PIERCE COUNTY TERMINAL WHARF AND PHASE 2 DREDGING AND SLIP 5 MITIGATION CONTRACT NO. 998149

MANSON/TRAYLOR RECORD DRAWINGS

RECORD DRAWINGS

THESE RECORD DRAWINGS HAVE BEEN PREPARED BY ENGINEERING CONSULTANTS BASED UPON MARKUPS AND INFORMATION FURNISHED BY MANSON/TRAYLOR JV. WHILE THIS INFORMATION IS BELIEVED TO BE RELIABLE, THE CONSULTANTS CANNOT ASSURE ITS ACCURACY, AND THUS IS NOT RESPONSIBLE FOR THE ACCURACY OF THESE RECORD DRAWINGS OR FOR ANY ERRORS OR OMISSIONS WHICH MAY HAVE BEEN INCORPORATED INTO IT AS A RESULT. THOSE RELYING ON THESE RECORD DRAWINGS ARE ADVISED TO OBTAIN INDEPENDENT VERIFICATION ON THEIR ACCURACY BEFORE APPLYING IT FOR ANY PURPOSE. INFORMATION THAT IS CLOUDED REPRESENTS CHANGES MADE TO THE DESIGN DRAWINGS.

EP-~~555117~~
D1
SHEET 136 OF 164
CONTRACT NUMBER: 998149
E NUMBER: E1972
PHASE: POST CONSTRUCTED

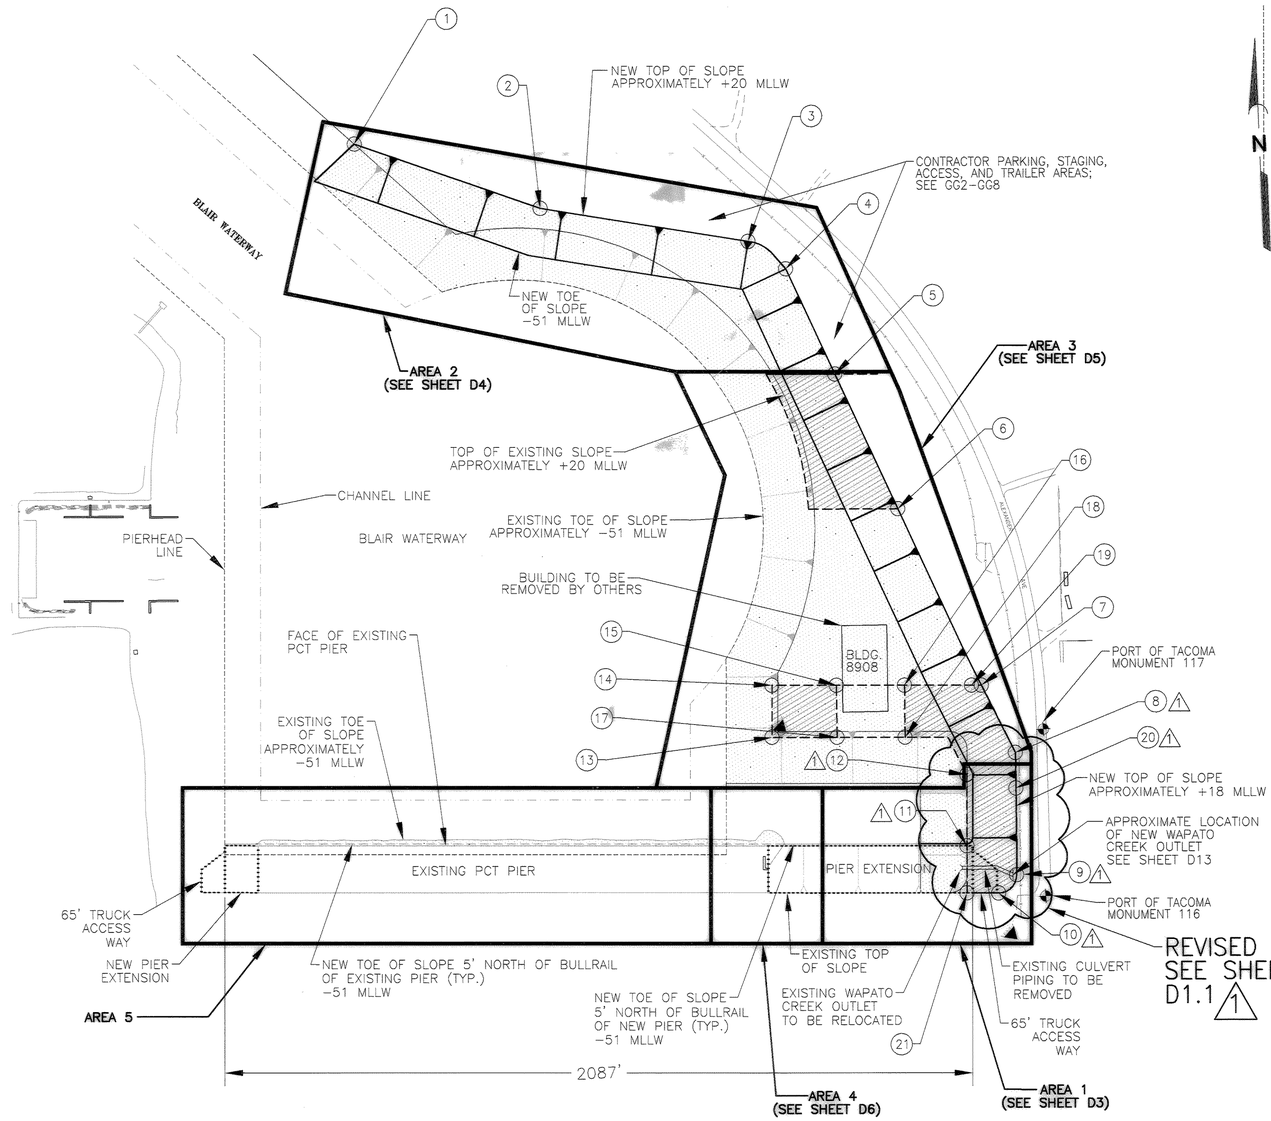
1 TOP OF SLOPE MOVED EAST PER RFI 63. SEE "AS-CONSTRUCTED" CONDITIONS ON SHEET D1.1.

EP-~~556-17~~
D3
SHEET 139 OF 164
CONTRACT NUMBER 998149
F NUMBER F1972
PHASE POST CONSTRUCTED

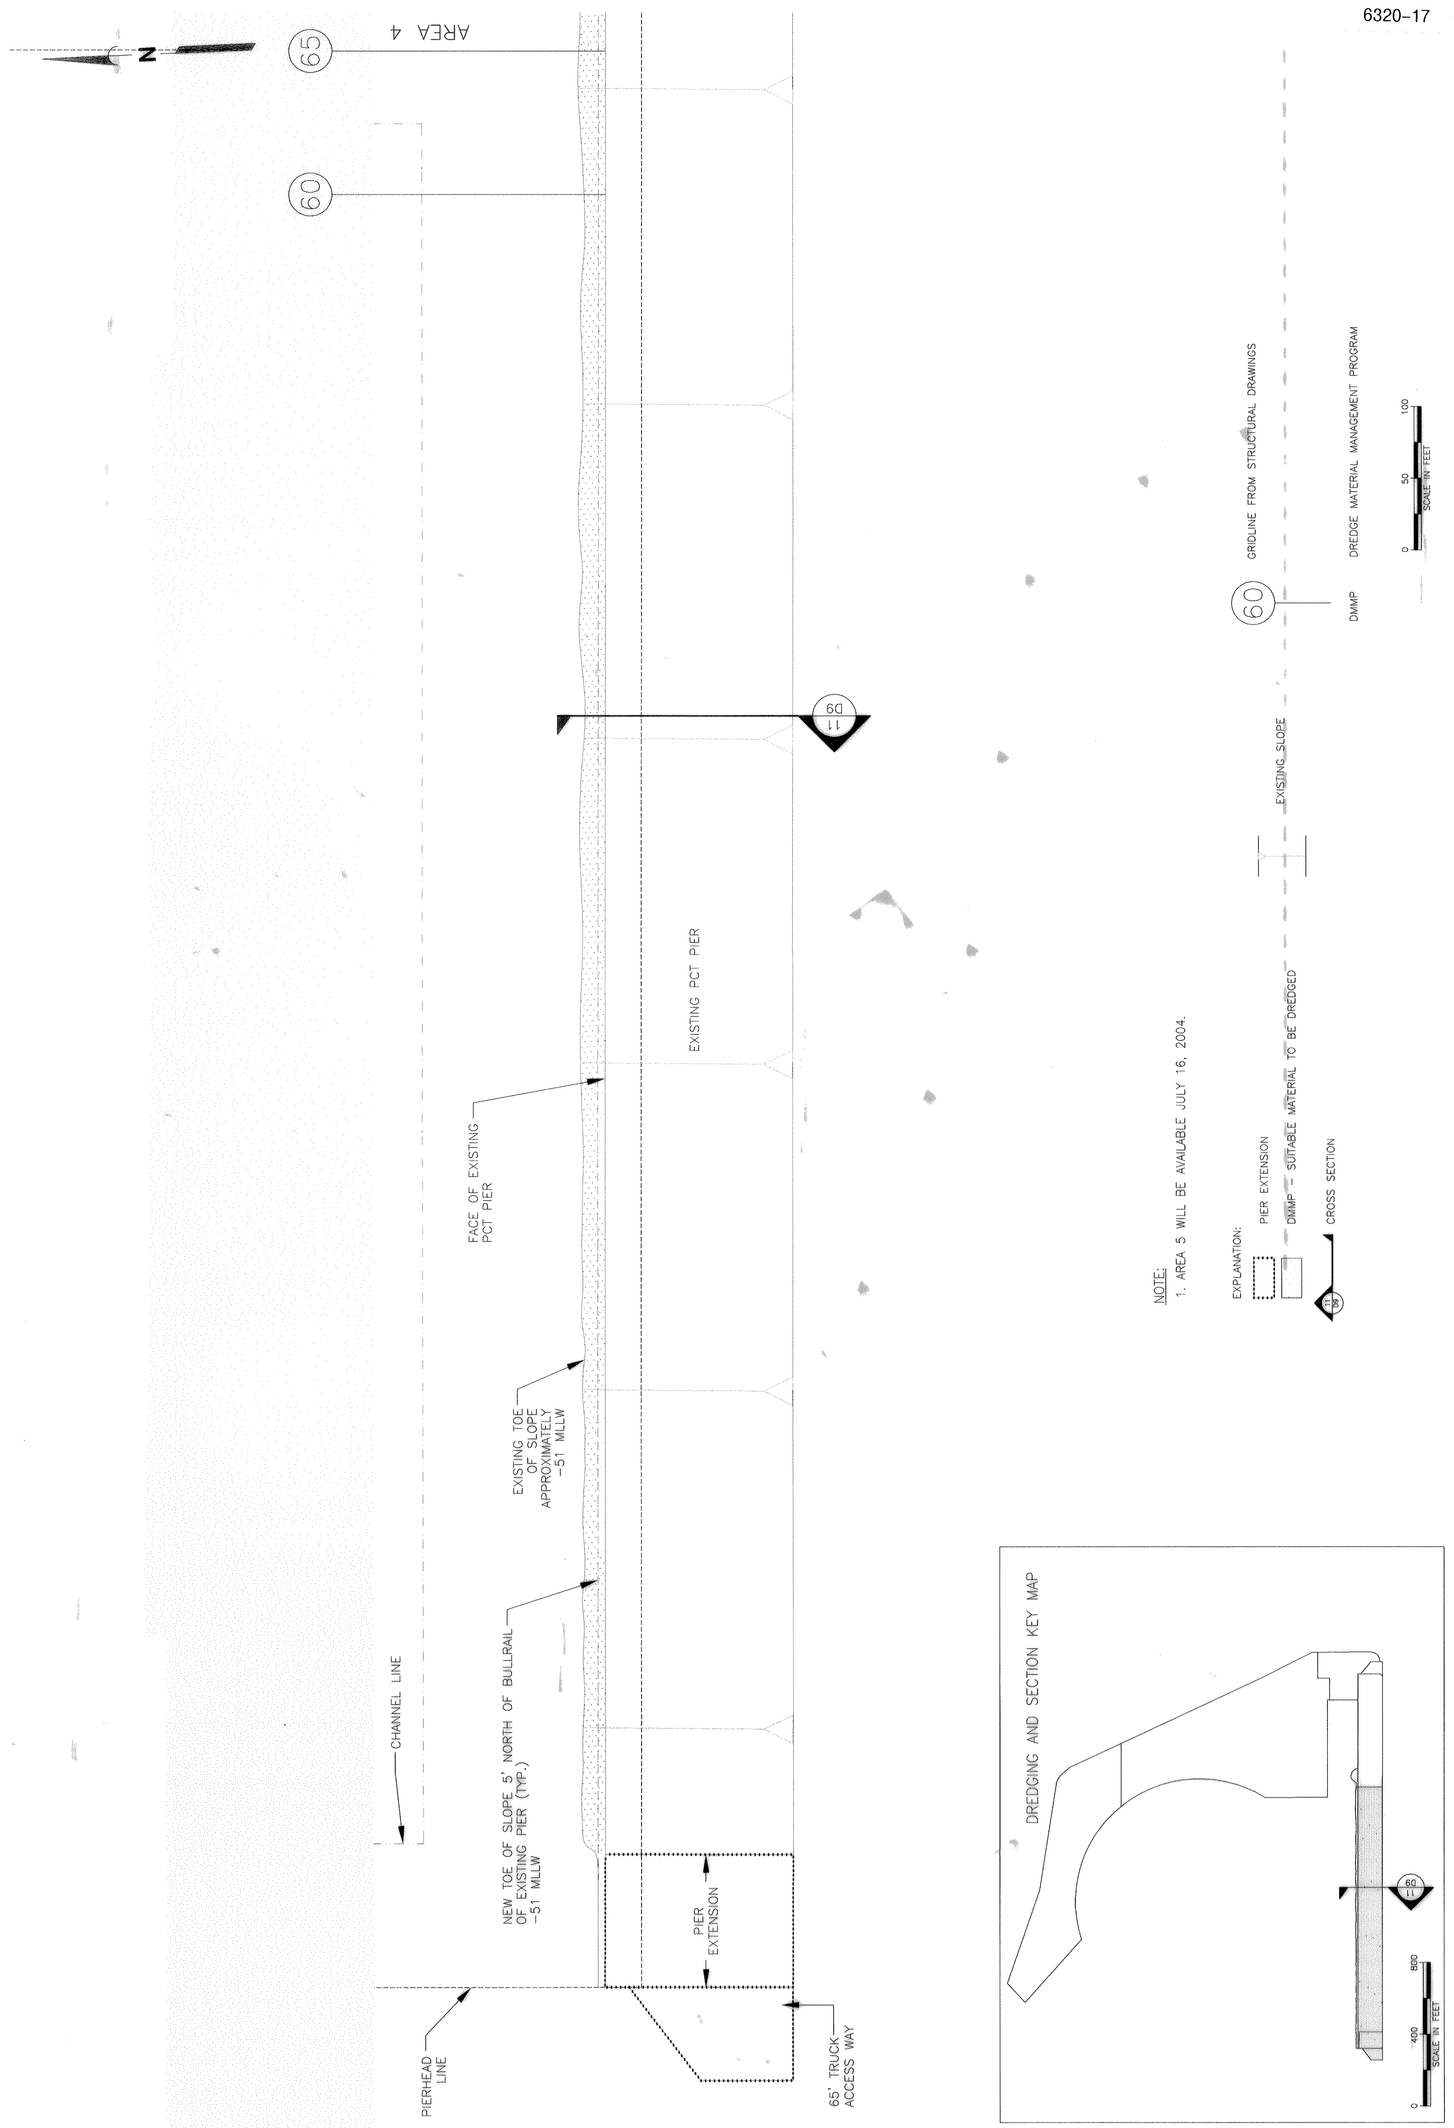
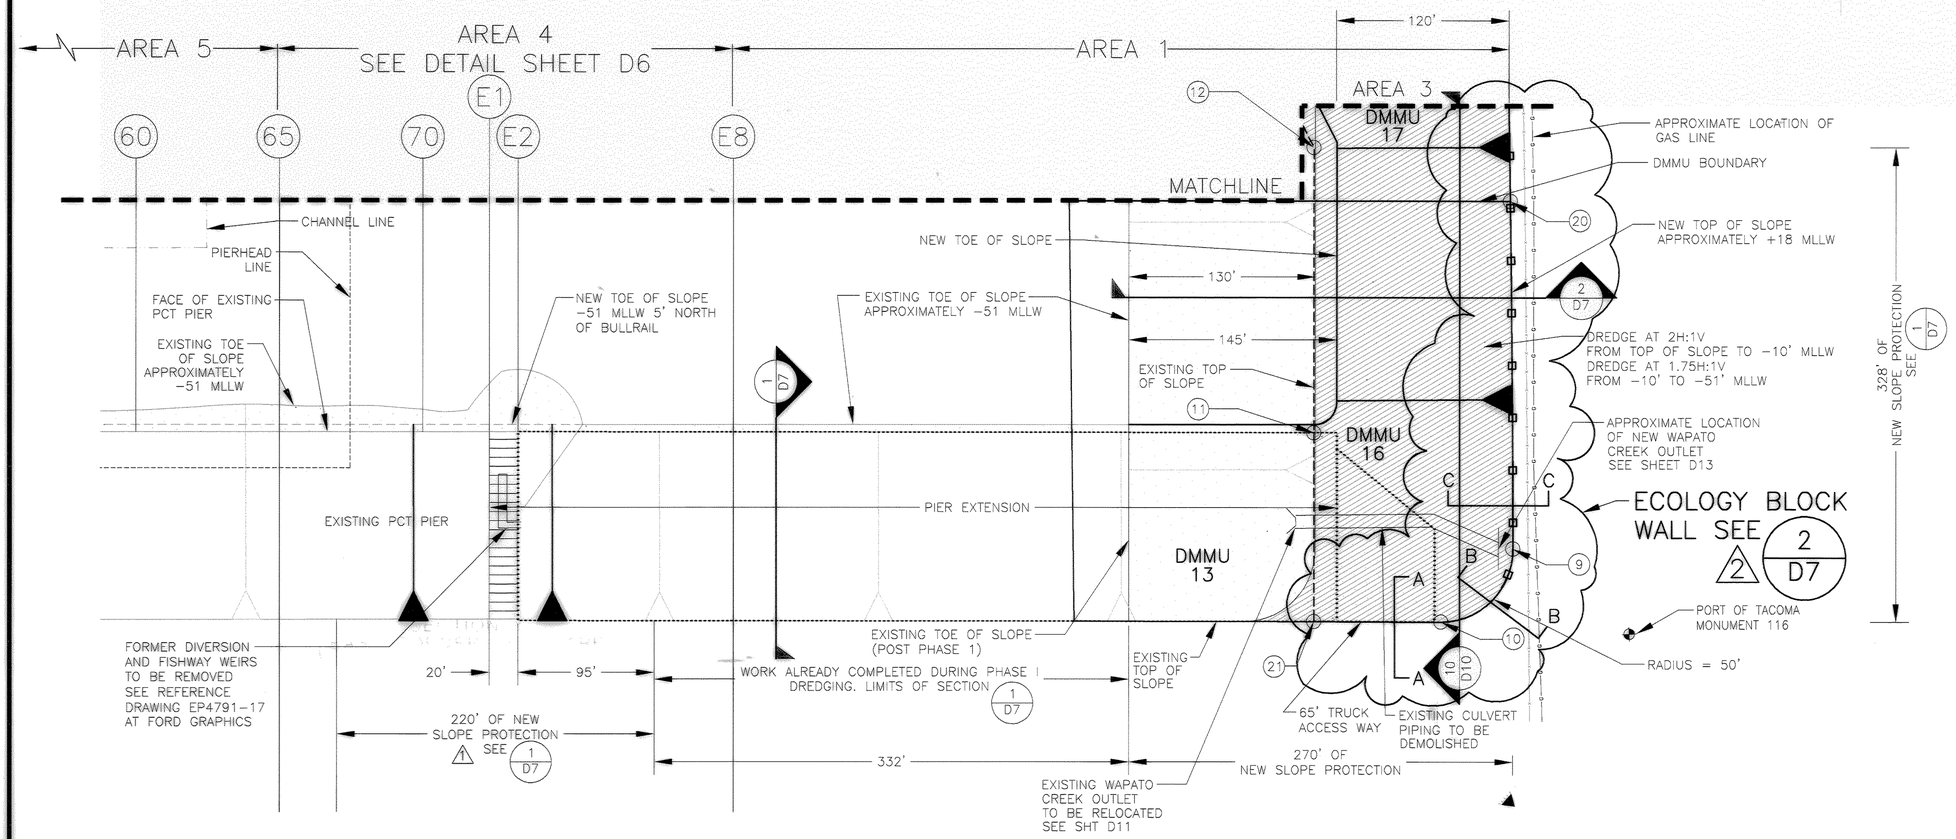
2 ECOLOGY BLOCK WALL MODIFIED AND EXTENDED PER RFP 00019. SEE SECTIONS A, B, AND C SHEET D7.1.

DETAIL A – OUTLET PLAN

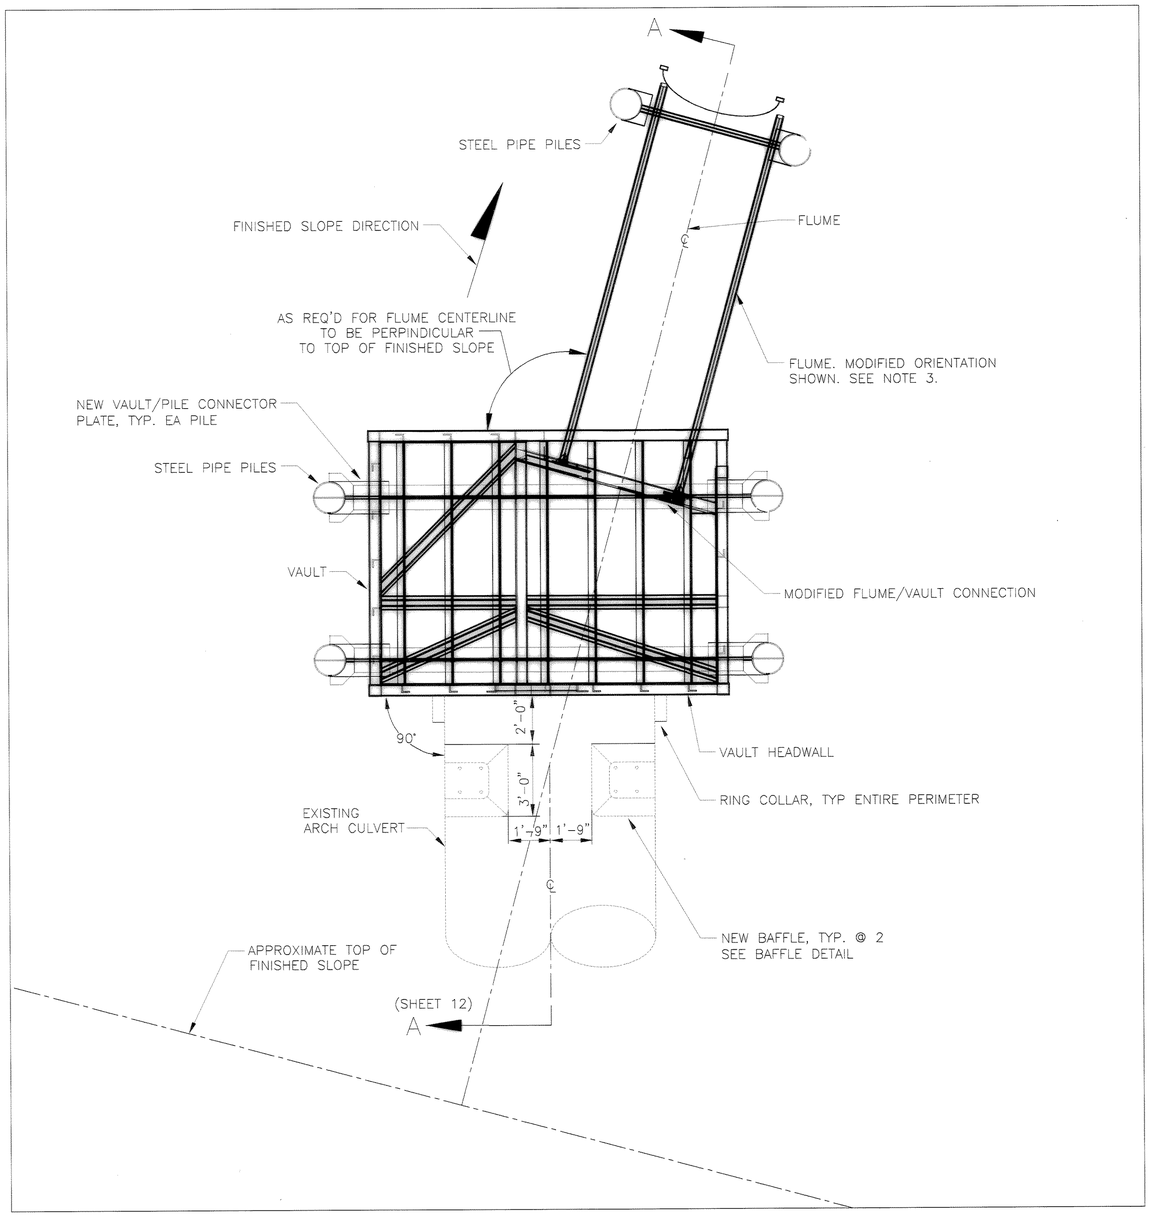
1 WAPATO CREEK OUTLET LOCATION MODIFIED. SEE SHEET D13.1.

SHEET 31 OF 164
C26

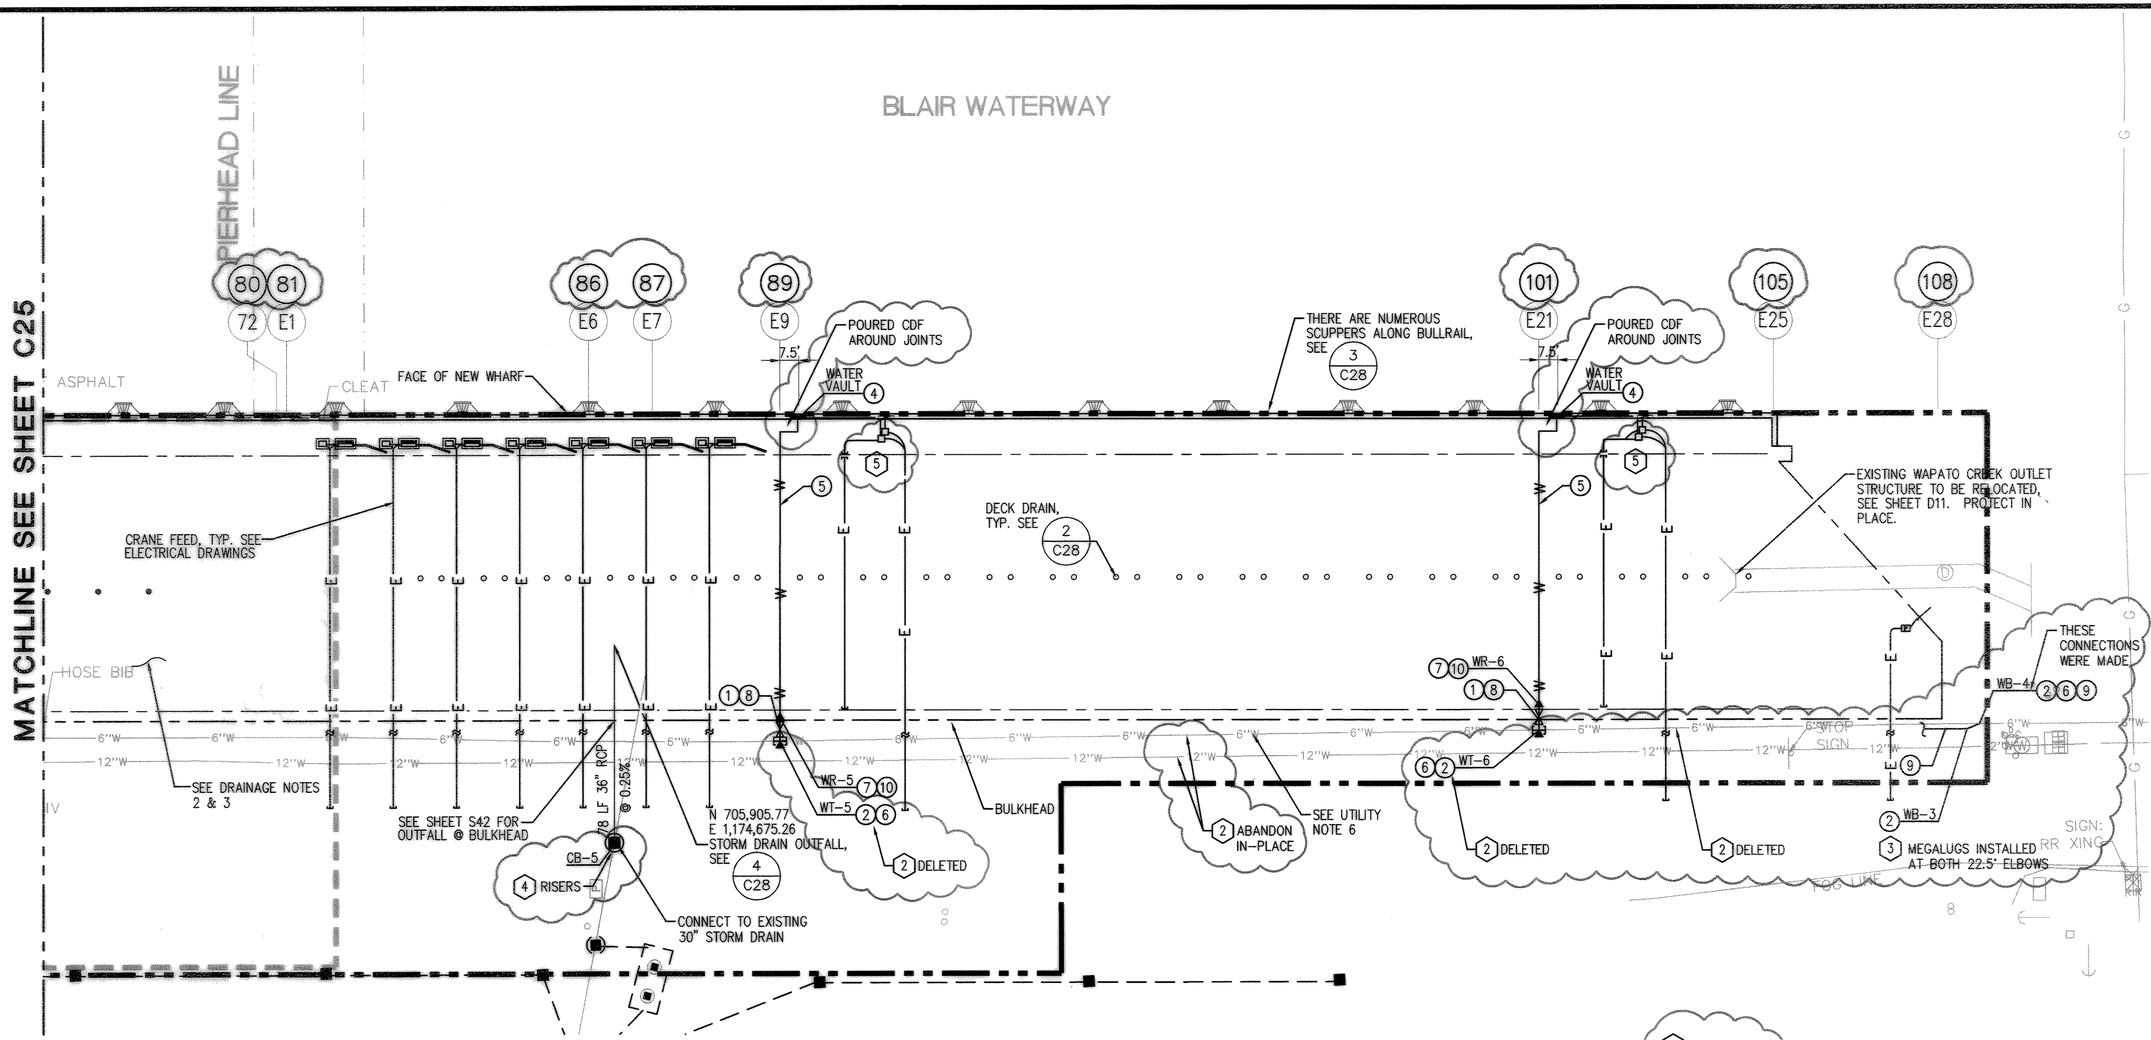
1. RFI 093
2. RFP 16
3. MEGALUGS INSTALLED AT BOTH 22.5°ELBOWS
4. SUBMITTAL 02400-08, SEE DWG H02 ON BACK OF C25.
5. ALL ELECTRICAL CONDUIT NORTH OF O/B CRANE BEAM ENCASED IN RED CDF.
